**TOWN OF NISKAYUNA**  
***Planning Board and Zoning Commission***

**Agenda**  
**September 11, 2023**  
**7:00 PM**

**ITEM TITLE:** RESOLUTION: 2023-19: A resolution for site plan app for a 55-unit senior apartment building containing 2,000 sq. ft. of mixed-use commercial space and a 3,000 sq. ft. commercial space outbuilding at 2837 Aqueduct Rd. -- Rivers Ledge.

SHEET 0-1

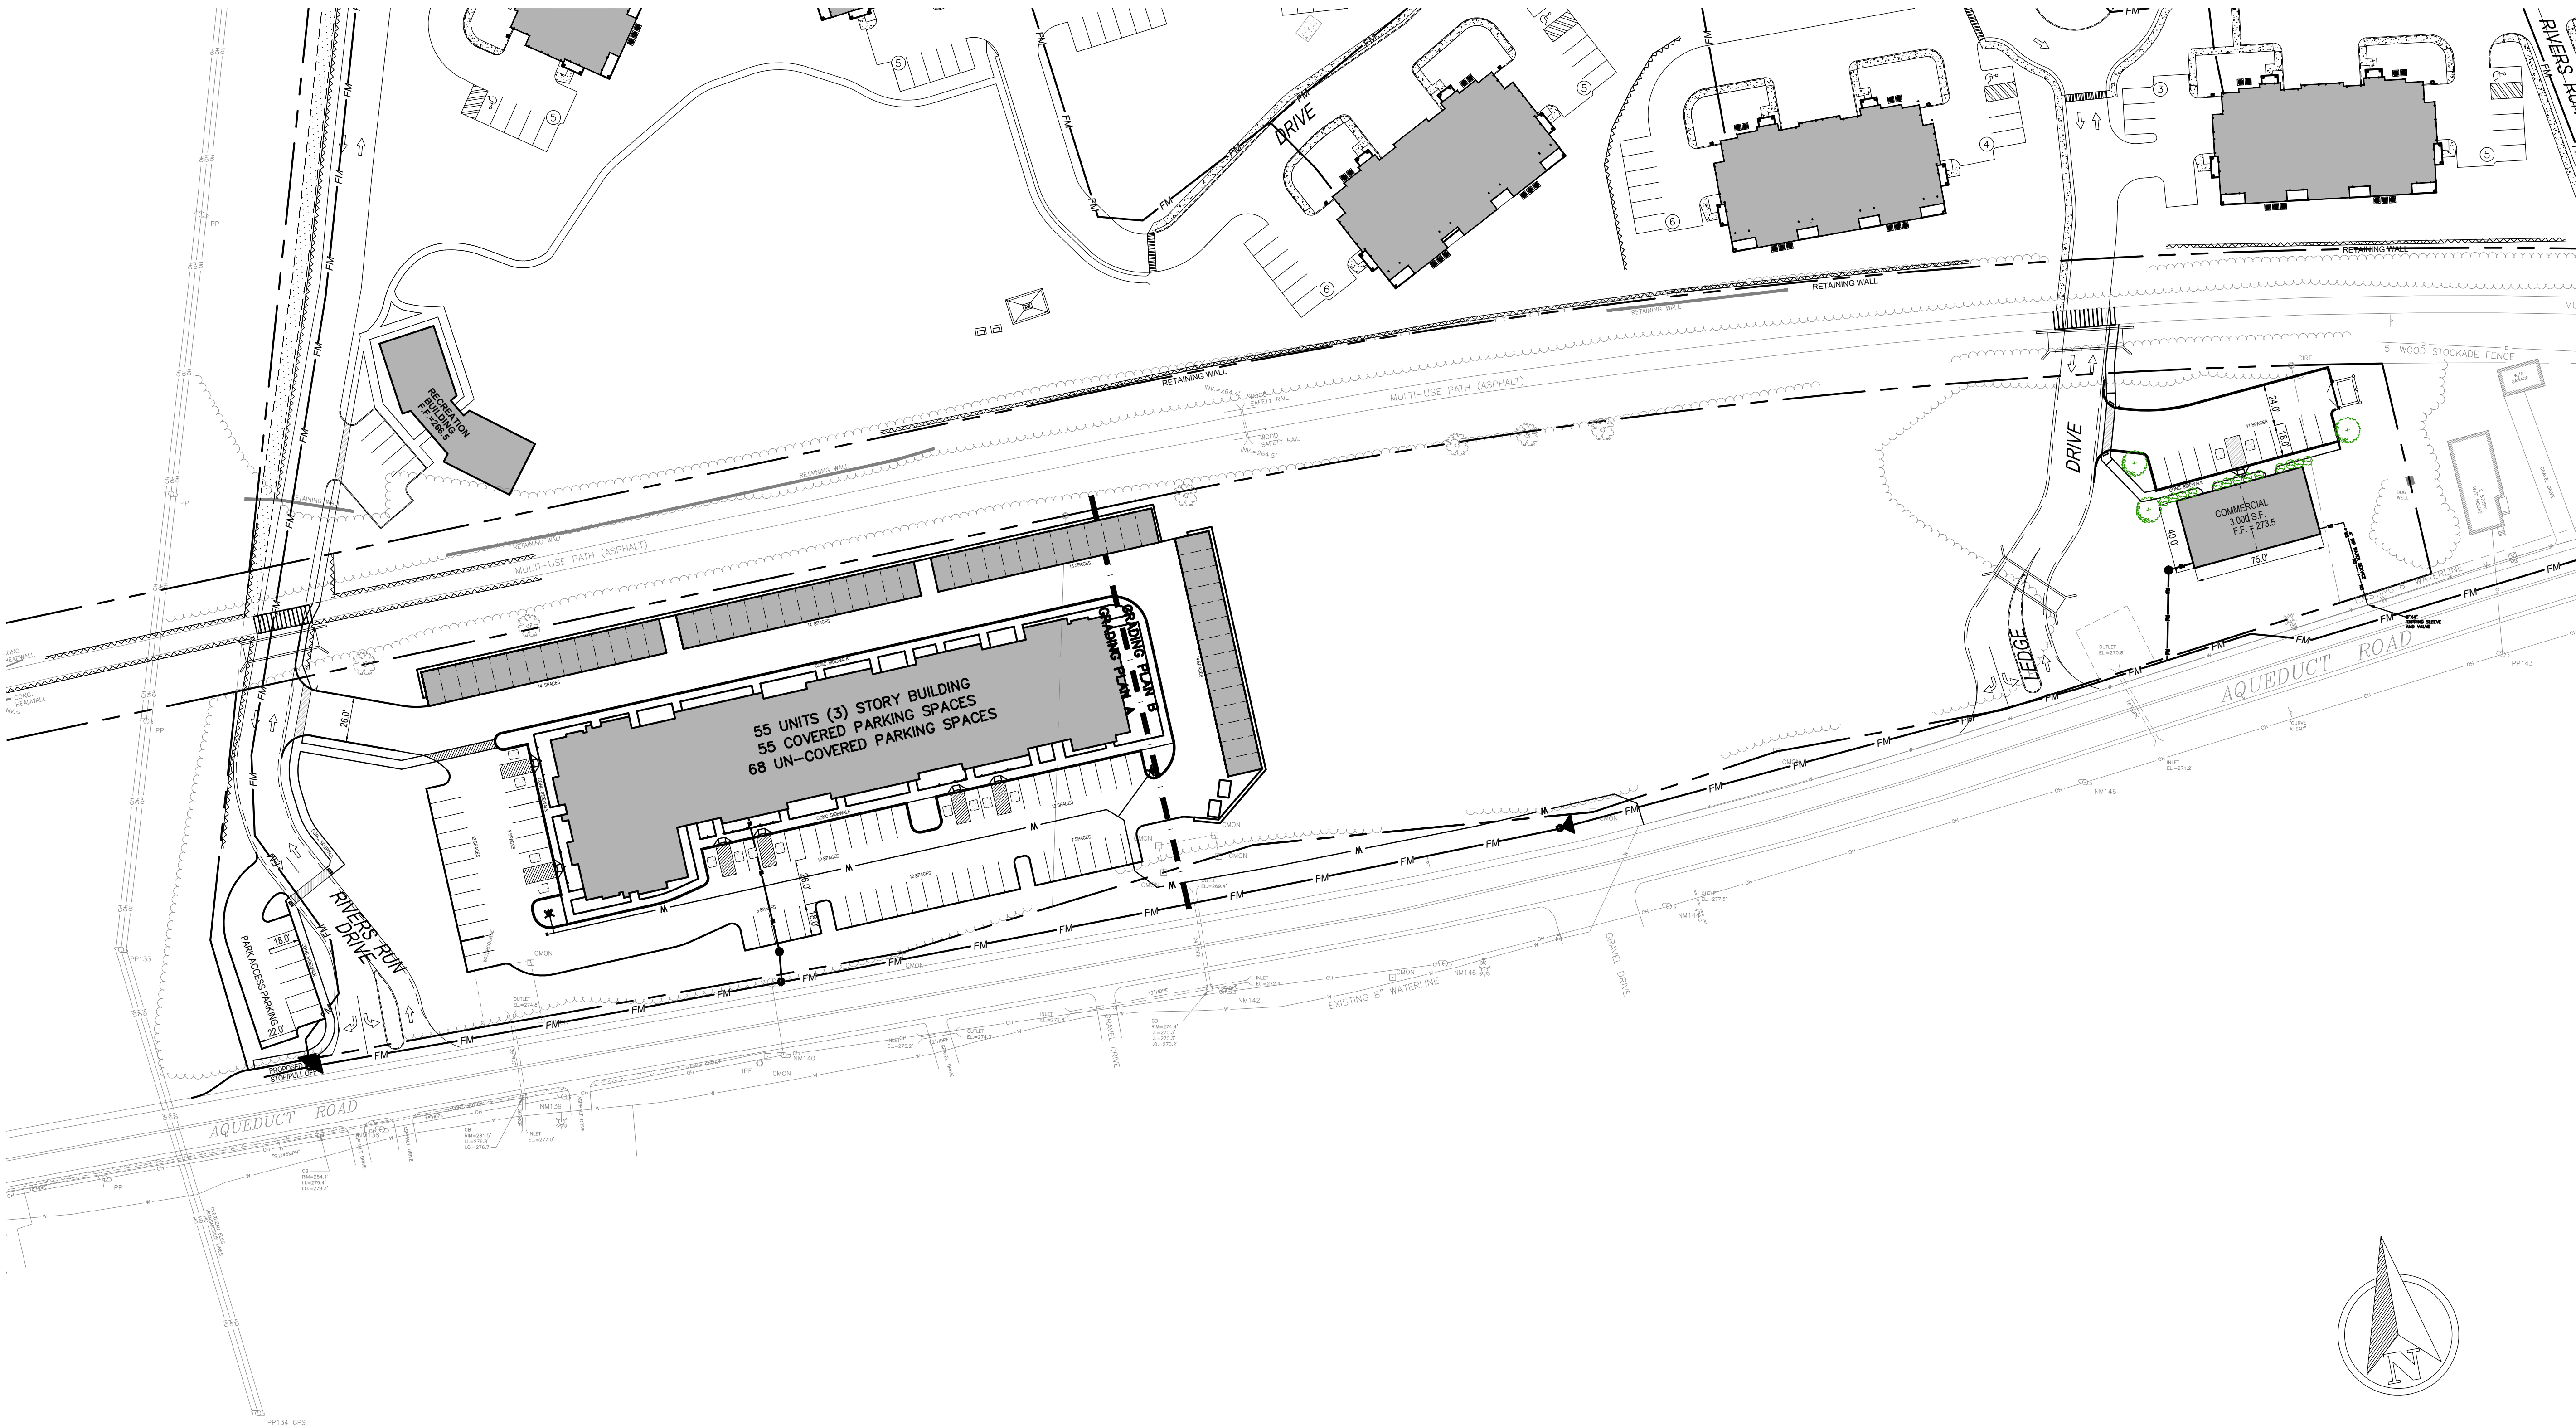
1. Add an outdoor seating / dining area – possibly between the Sr. Center Building and River Run Drive.
2. Explore transit opportunities / bus stop on premises.
3. Break up the sea of asphalt around the Sr. Center building
4. Show that the inside includes entrances and exits that are conducive to walking to the covered parking garages. Consider covered walkways from the building to the garages.
5. Include setback dimensions from the proposed garages to the property lines.

1. Add at least 1 pick up area in the front and back of the main building
2. Include setback dimensions on the site plan drawing
3. Provide a more accurate rendering of the bike path and back of the garage area
  - a. Show what it would look like with mature trees
  - b. Add lights along the bike path
4. Provide a rendering of the front of the garage without the two rows of shingles
5. Repair the damaged lawn on Aqueduct Rd.
6. Complete the installation of the required sidewalk (Phase 1) and design the additional sidewalk for installation during Phase 2
7. Install the pressure reducing valve (Phase 1)

- ii. Adding setback dimensions to the site plan drawings
